W.P. 438-64-00, Site 3-288,
Interchange Underpass at Connection to Hwy. 15,
Highway 417, District 9 - Ottawa

FOUNDATION INVESTIGATION REPORT
For
Proposed Underpass Structure at the
Crossing of Hwy. #417 and Hwy. #7
Connection -- Township of Huntley
Reg. Mun. of Ottawa - Carleton
District No. 9 (Ottawa)
W.O. 71-11030 -- W.P. 438-64-00

SUBJECT: Hwy. #7 Connection Interchange, Underpass,
Approximately 1 Mile West of Regional Road 5,
W.P. 438-64-00; Site 3-288, Hwy. #417,
District #9

Hwy. #7 Connection Interchange U'Pass,
Site 3-288, W.P. 438-64-00,
Hwy. #417, District #9, Ottawa.

CONTRACT No. [Blank]
 DRAWING No. D-7072-1

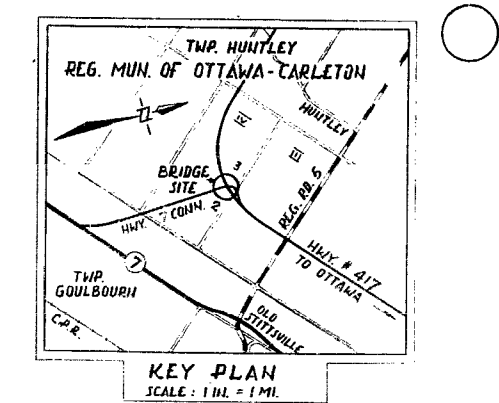
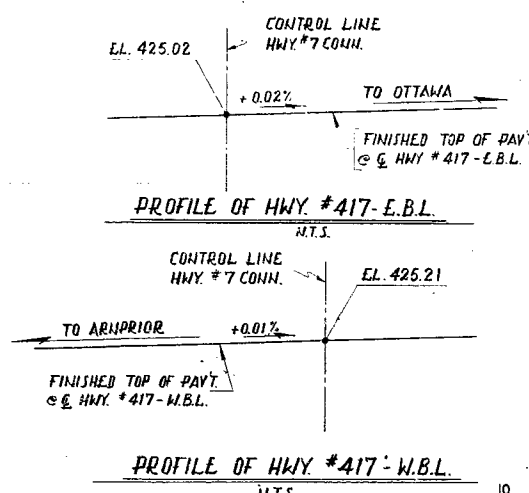
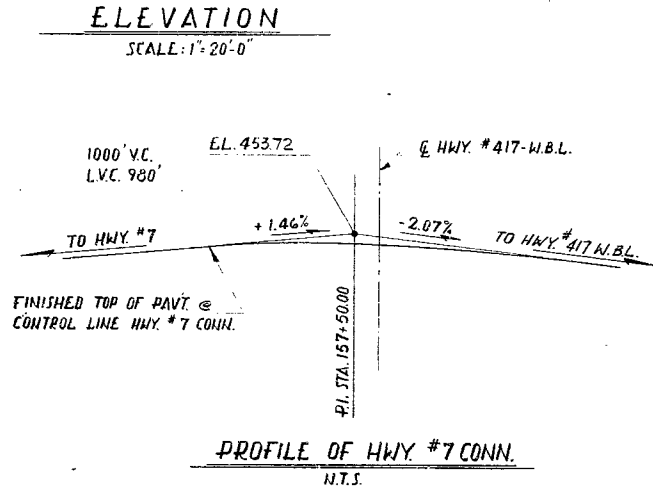
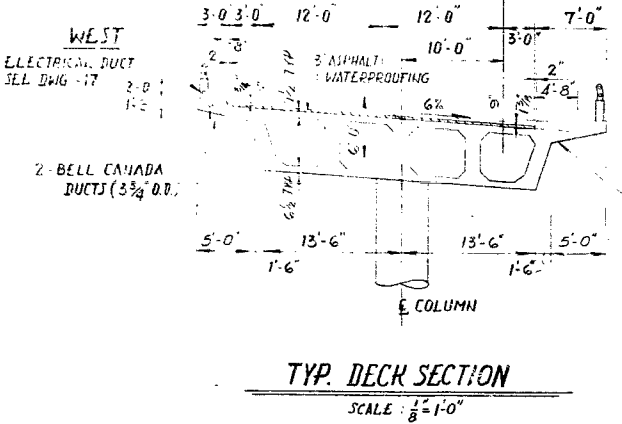
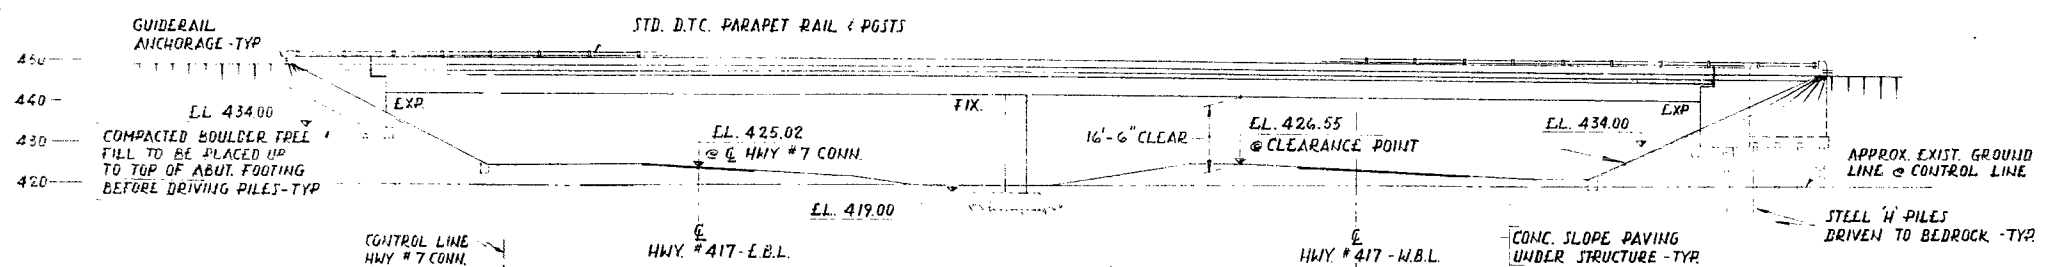
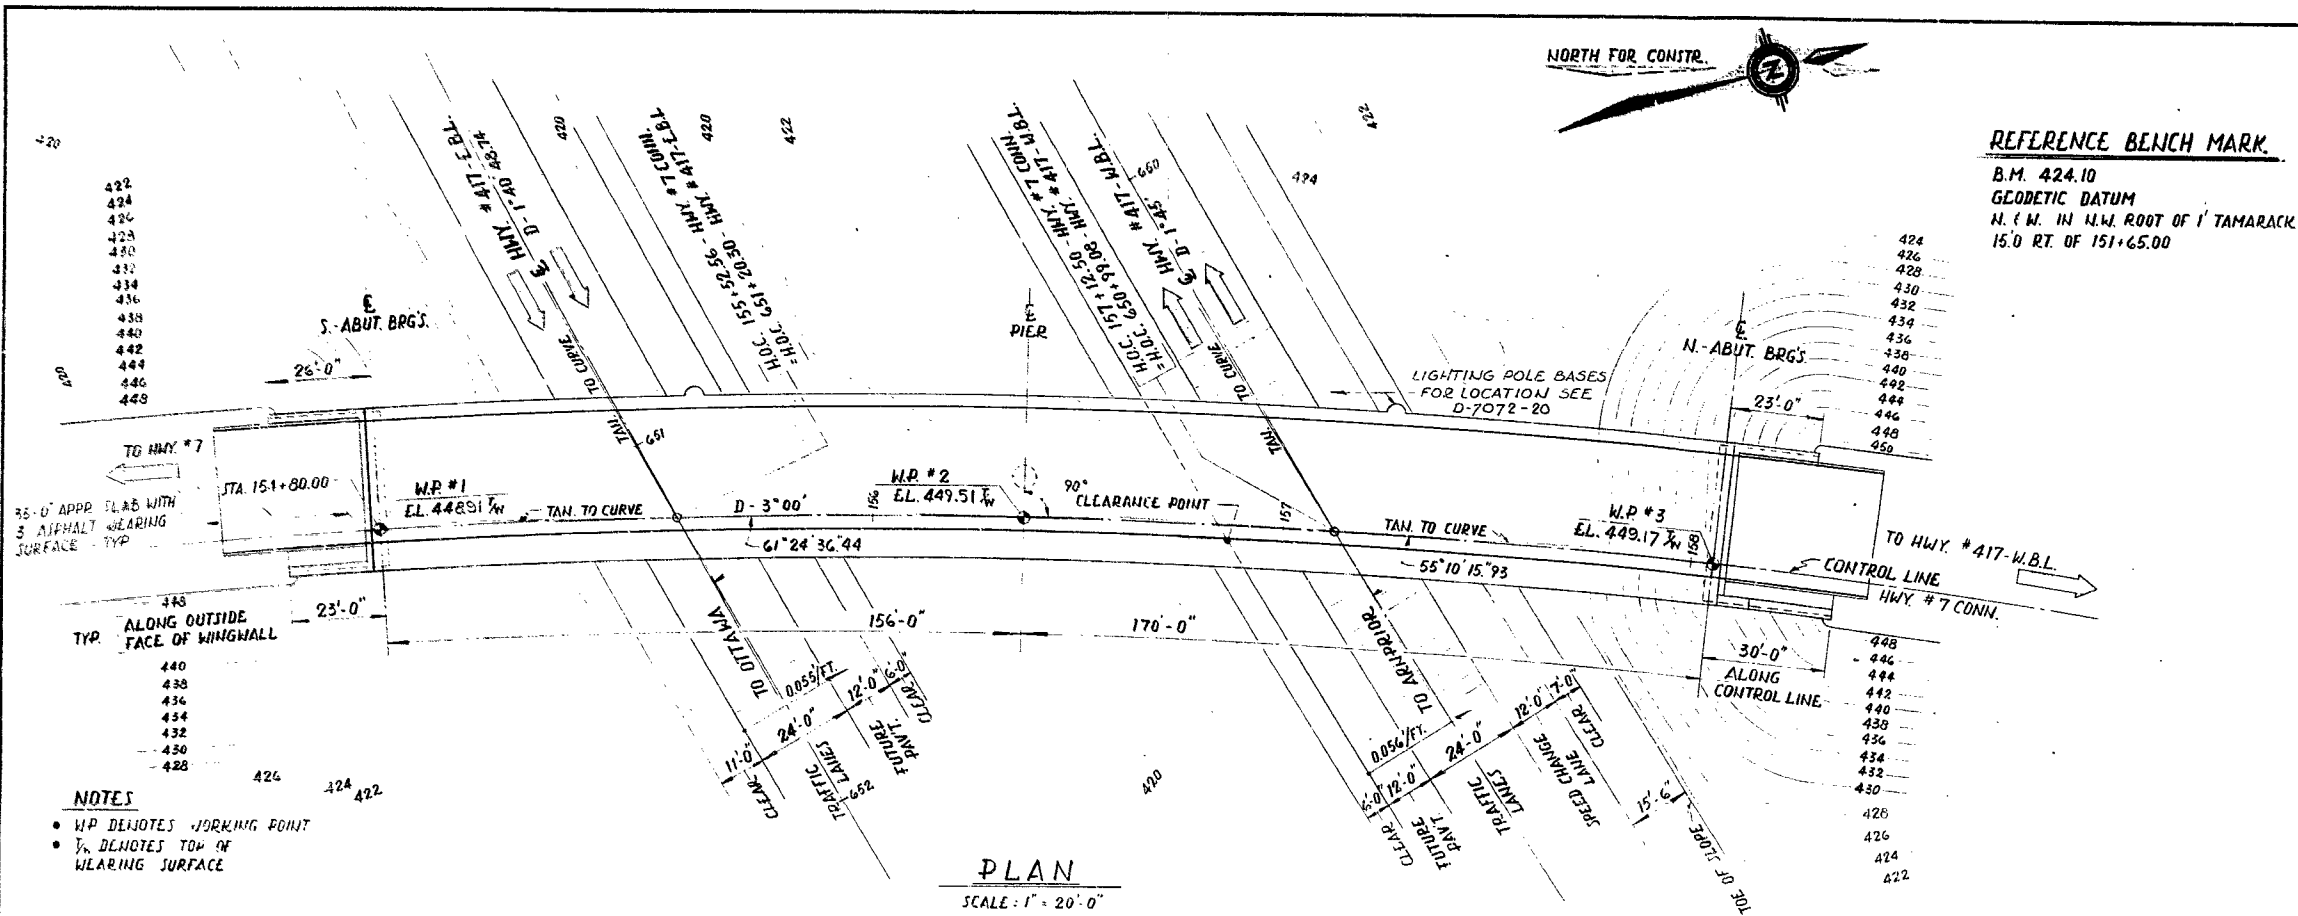
We have reviewed the final Bridge Drawings D-7072-1 and D-7072-3 and submit the following comments:—

- i) our comments of August 30/71 are still applicable
- ii) No mention is made of the removal of soft peat, as advised in our foundation Reports 71-11030. Hope the systems Design Drawings

- i) The Foundation Office advised on August 30, 1971, that in the vicinity of B.H. #3 the bedrock in the upper portion is fractured and we suggest the following methods.
 - a) Remove all fractured rock and replace with mass concrete.
 - b) Alternatively reduce the allowable bearing pressure to 10 t.s.f.
- ii) It is recommended in our Foundation Report W.O. 71-11030 (page 7) that the peat be completely subexcavated from within the plan limits of the proposed approaches. It is expected that these details will be shown on the Systems Design Services.

The final bridge drawing D-7072-3, submitted to you for comments has a note, "All fractured rock in the vicinity of Pier Footing to be removed and footing to be embedded 6" into sound bedrock". This note is located above Section 2 on Drg. D7072-3. Please advise if this note is acceptable to you. For your information, the pier footing is designed for an allowable bearing pressure of 20 tons/ft. ².
